Subject: Final Environmental Assessment (EA)
Kalaiopua Place Improvements
Honolulu, Oahu, Hawaii
TMK: 2-5-19: 9 (portion)

FINAL ENVIRONMENTAL ASSESSMENT
AND FINDING OF NO SIGNIFICANT IMPACT
for
KALAIOPUA PLACE IMPROVEMENTS
Honolulu, Oahu, Hawaii
TMK: 2-5-19: 9 (portion)

KALAIOPUA PLACE IMPROVEMENTS
FIGURE 2-2
NEW PAVEMENT AND
GUARDRAIL SECTION

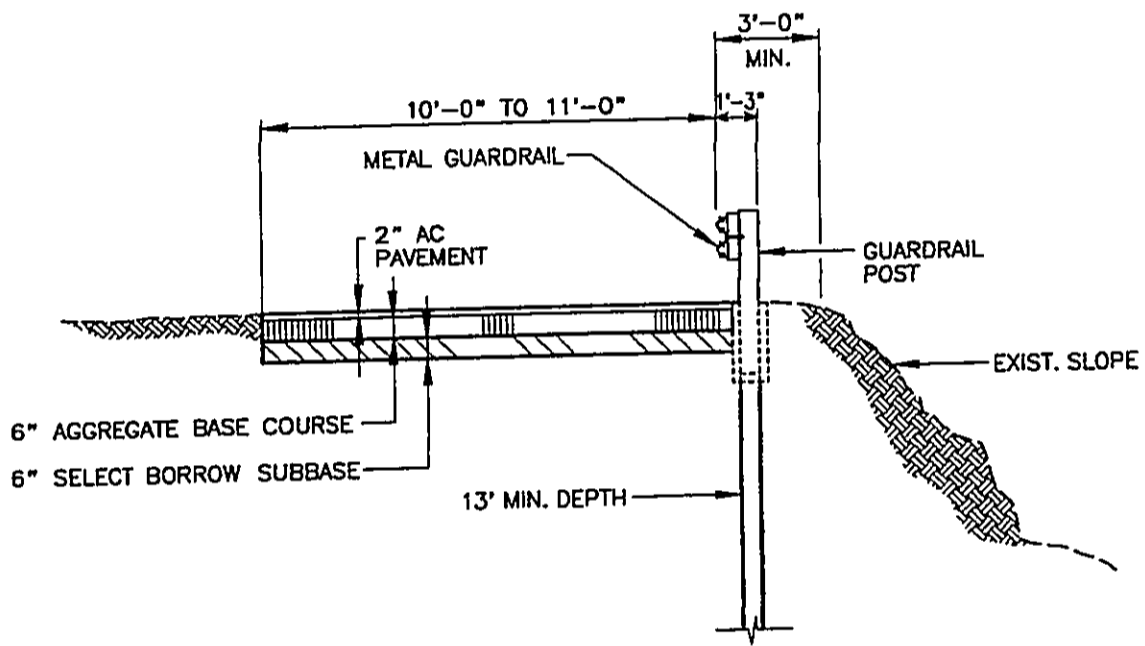
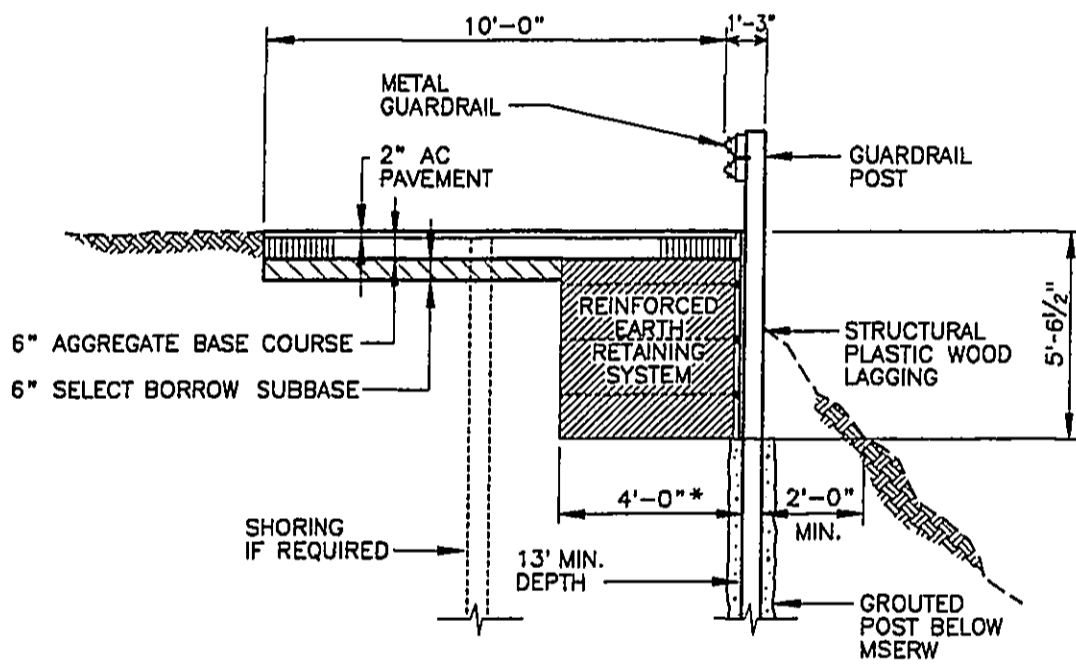
In the Final EA, Table 2-1 will be revised for consistency with Section 2.2.1 to indicate installation of guardrails along the entire length of road, except the last 90 feet, where an existing curb wall will be maintained for safety. Guardrails are also depicted on Figure 2-3 (Bridge Section) and Figure 2-4 (Mechanically Stabilized Earth Reinforced Wall Section).
